# Sydney Metro Martin Place

## North Tower Base Building Changes

*SSDA Stamped plans & FC2 Comparison*

*Rev #01 – 15/03/22*

# Level 01 Plan

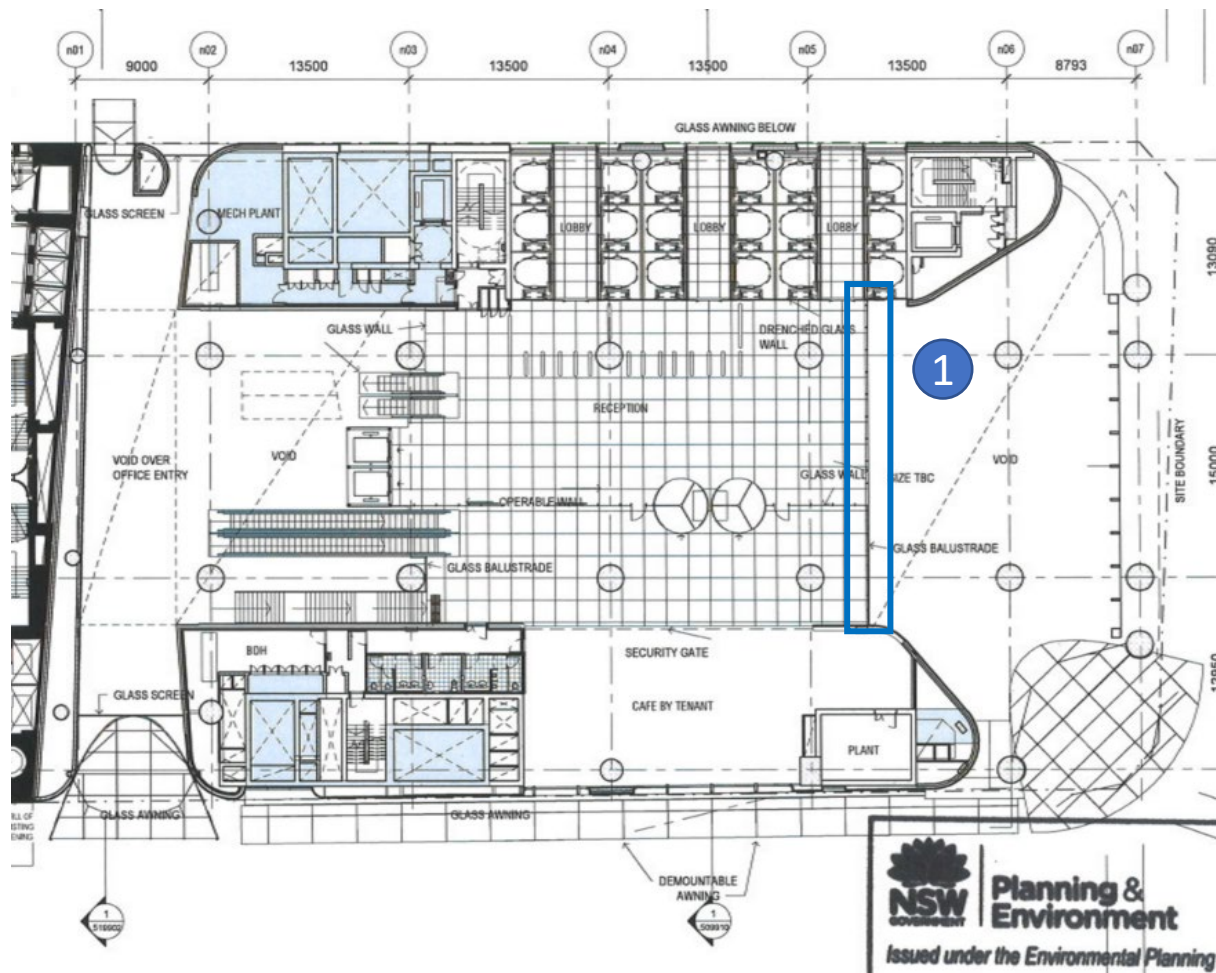
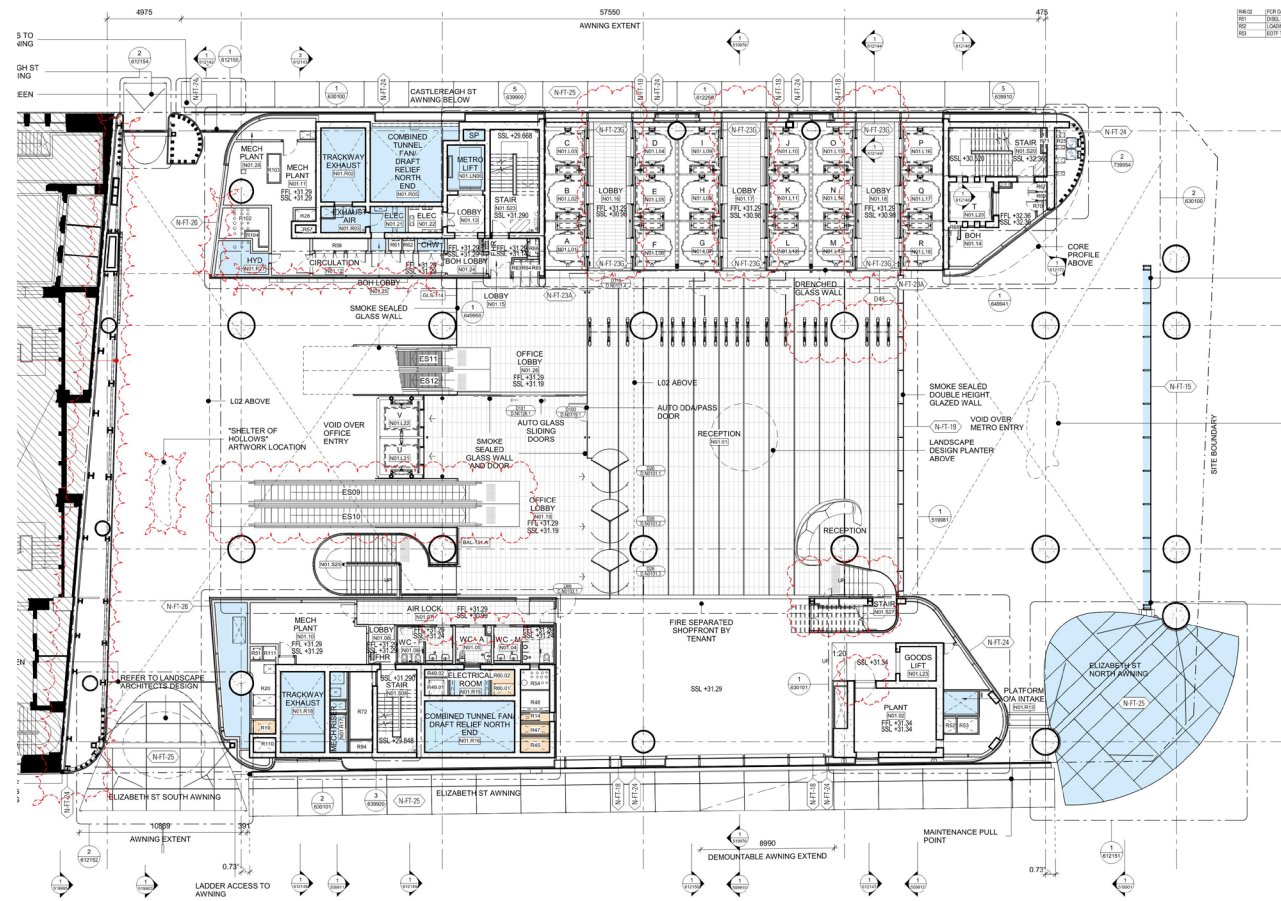
1.Alteration of approved open balcony to include full height glazing to northern end of lobby.

# Level 02 Plan

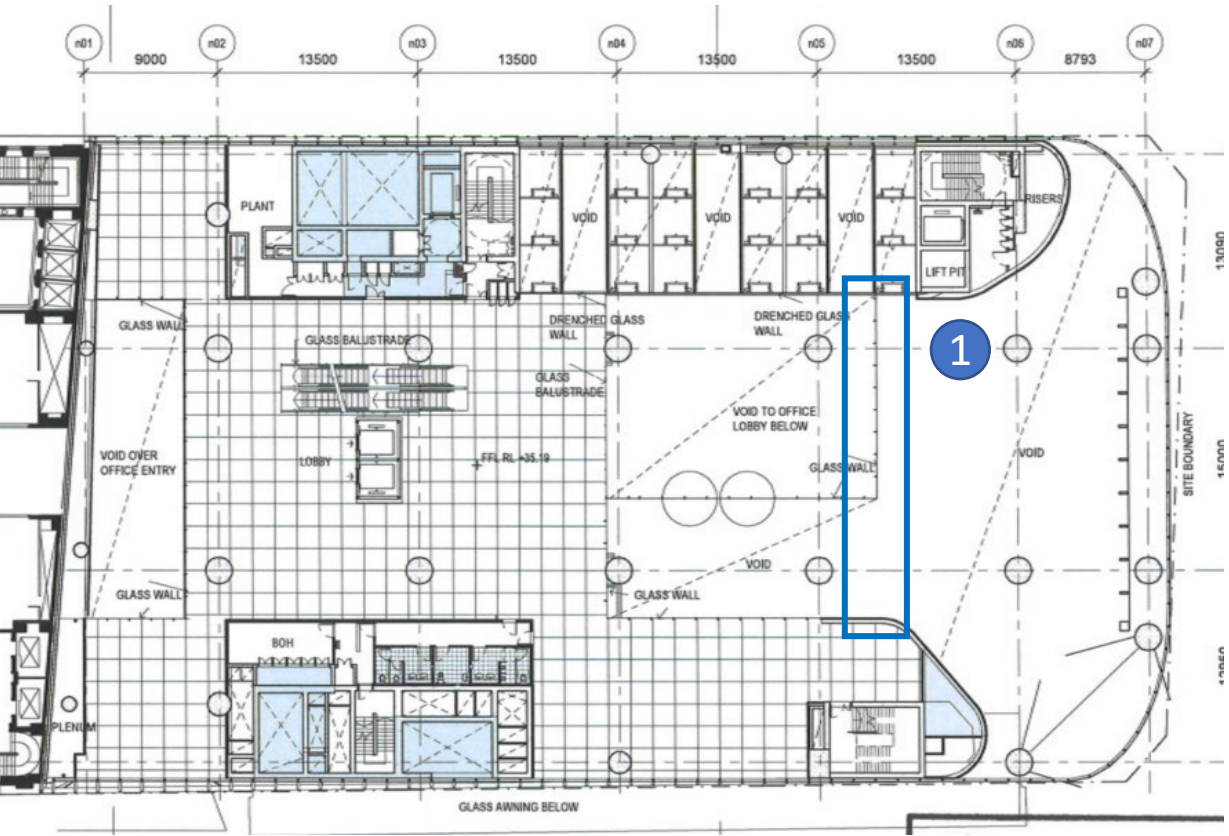
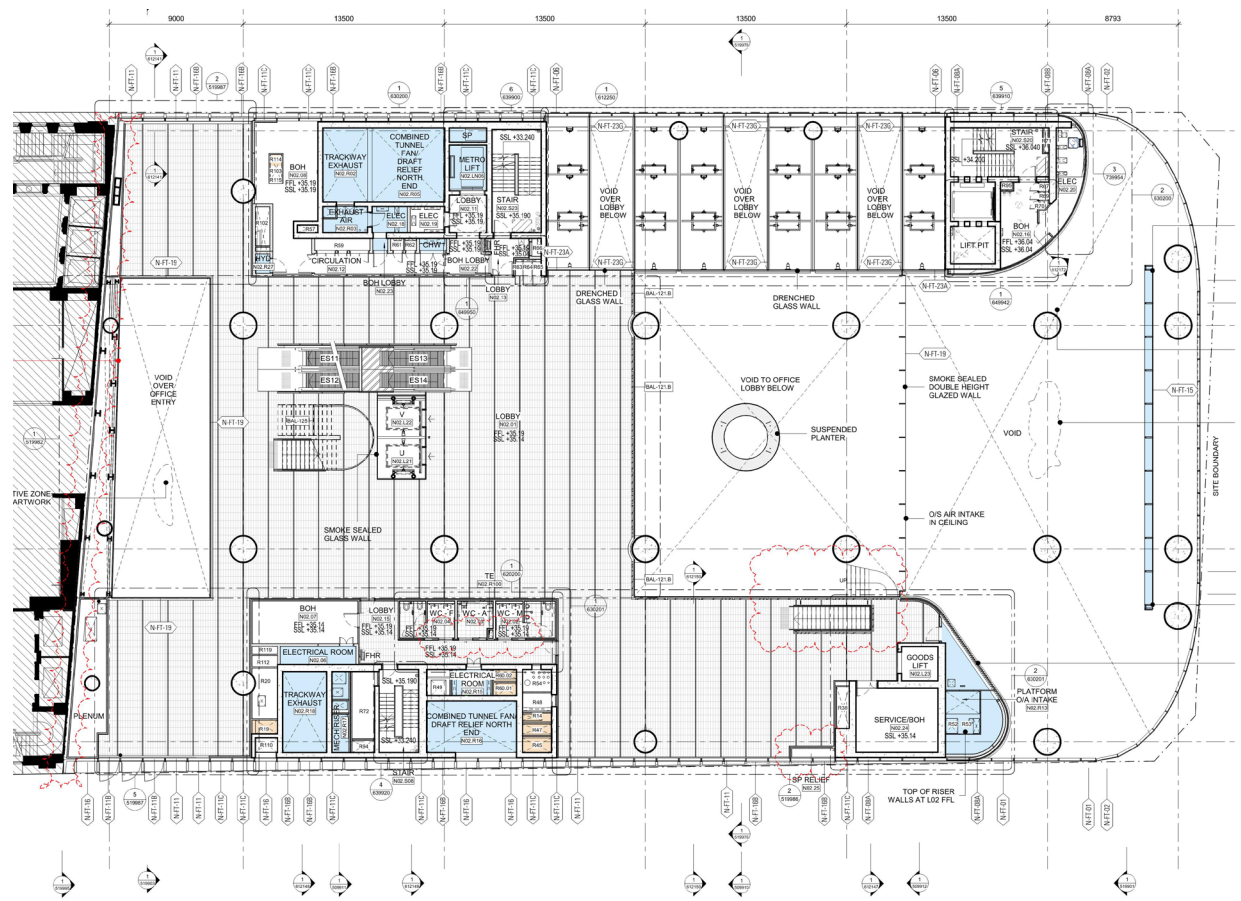
- 1. Alteration of approved open balcony to include full height glazing to northern end of lobby.

# Level 05 Plan

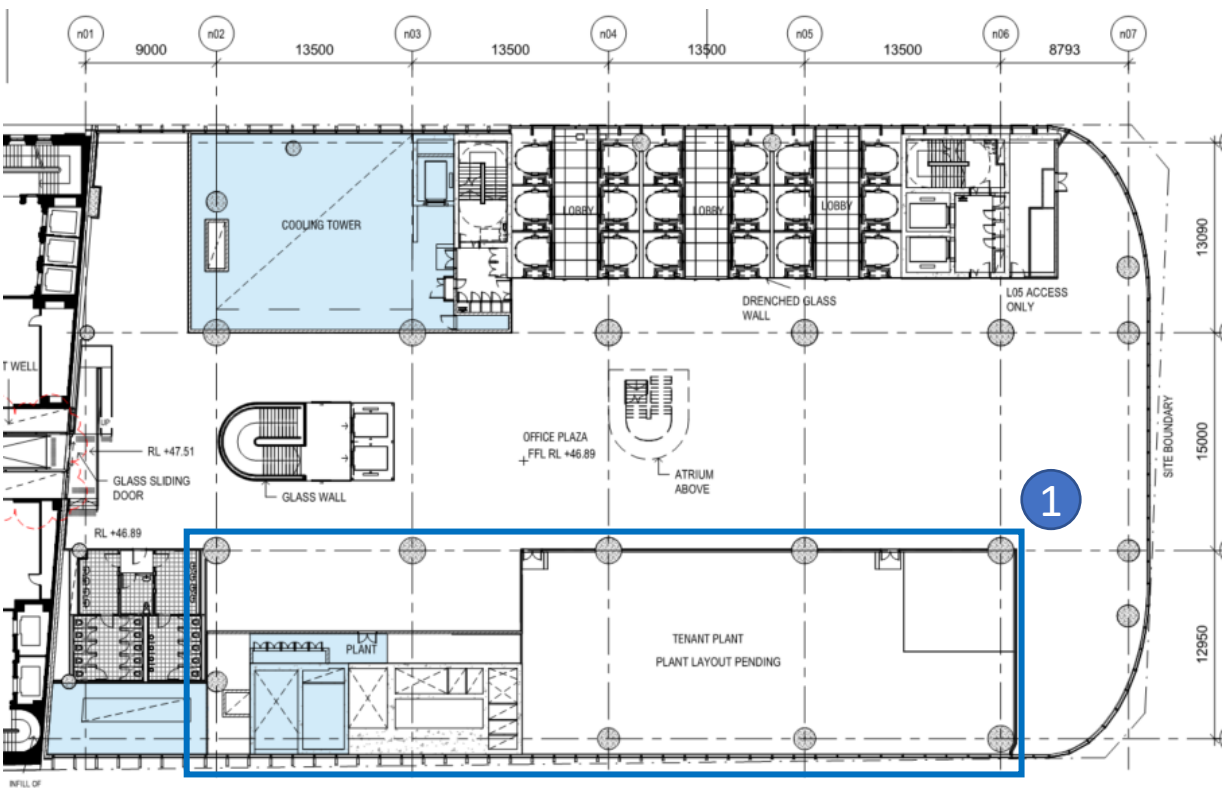
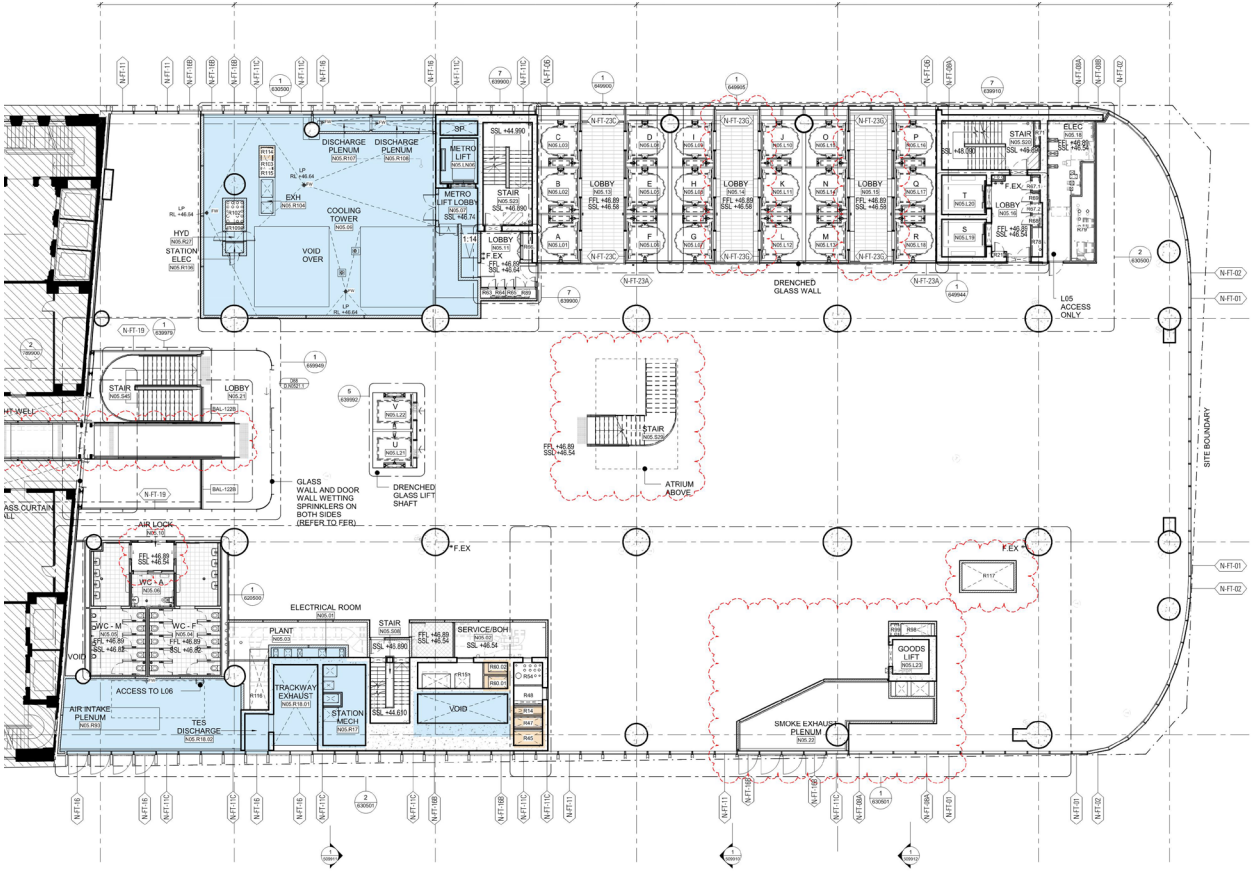
1. Relocation of tenant plant from Level 5 to Level 6.

# Level 06 Plan

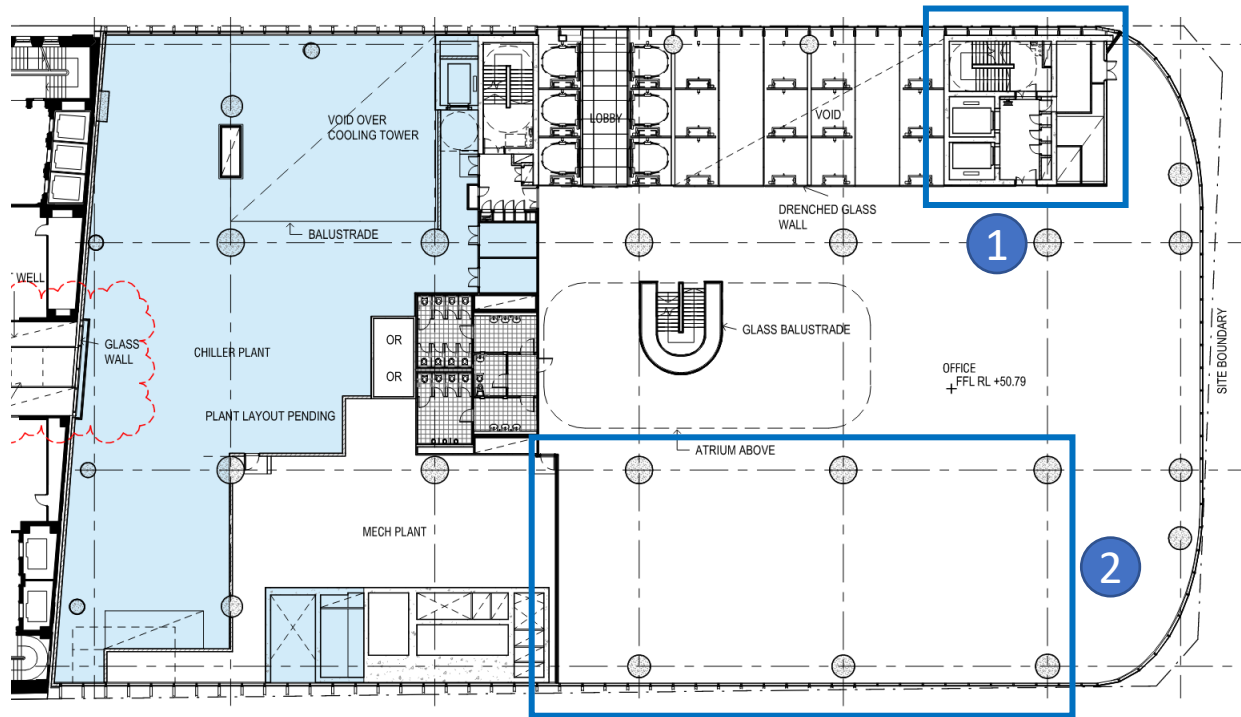
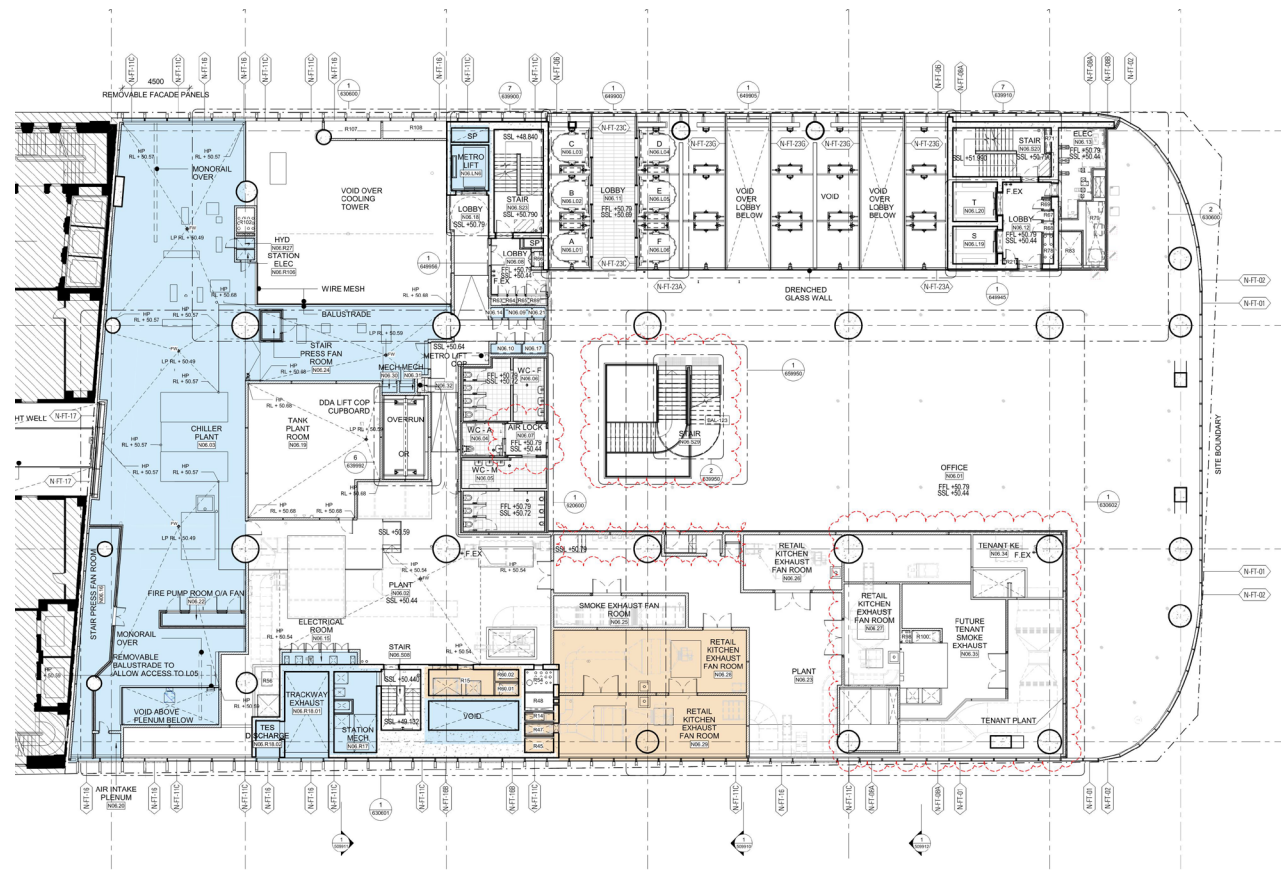
- 1. Minor alterations to arrangement of plant and services,
- 2. Relocation of tenant plant to level 6

# Upper Roof Plan

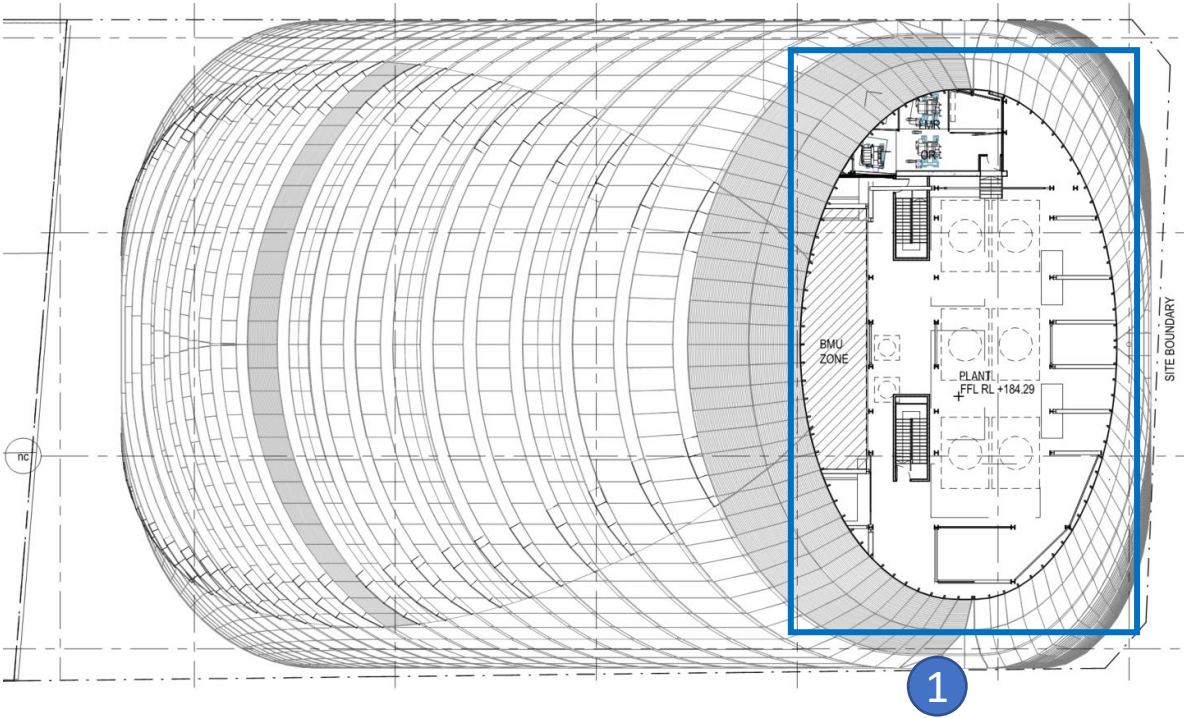
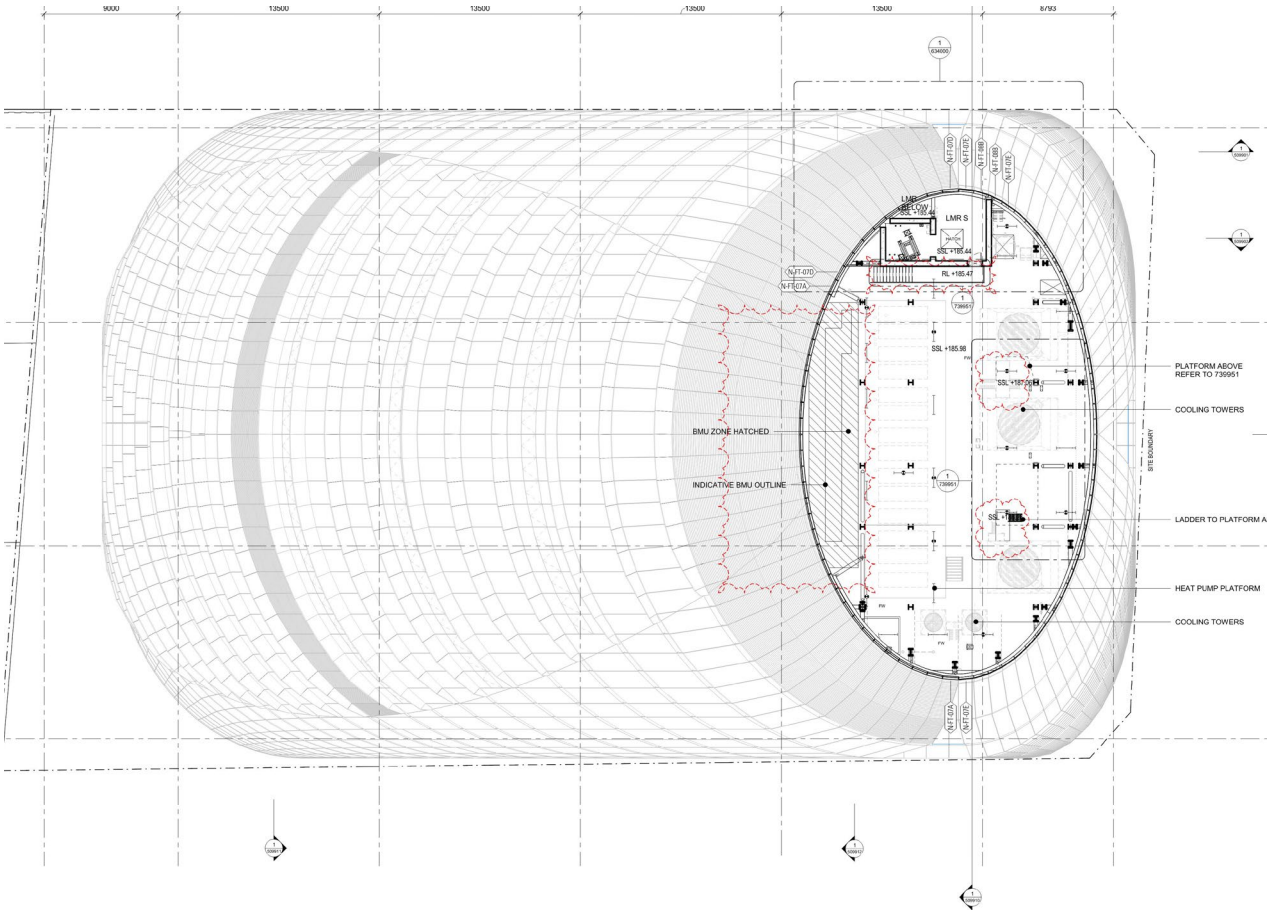
1. Lowering of floor level FFL

## West Elevation

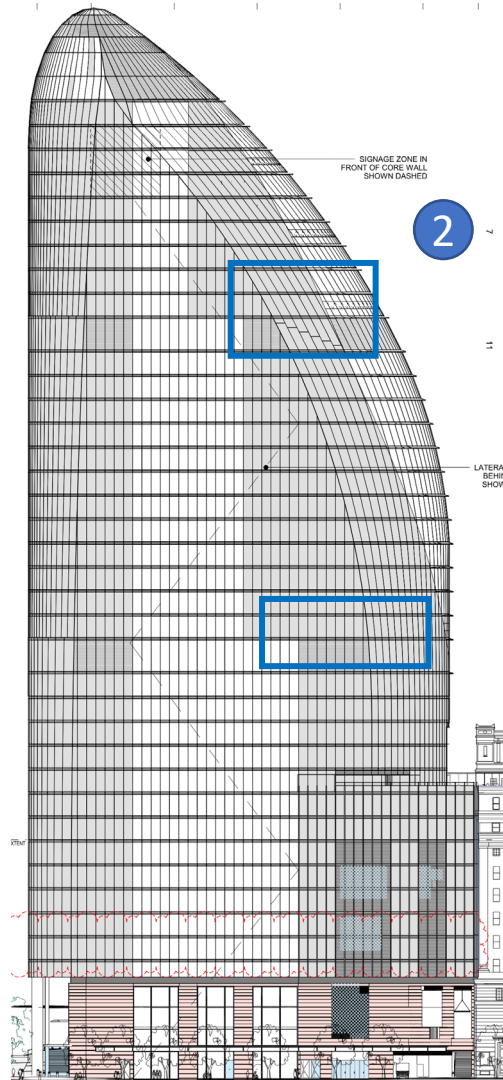
1. Increase in louvres on level 15 in lieu of glazing on western facade
2. Increase in louvres on level 28 in lieu of glazing on western facade
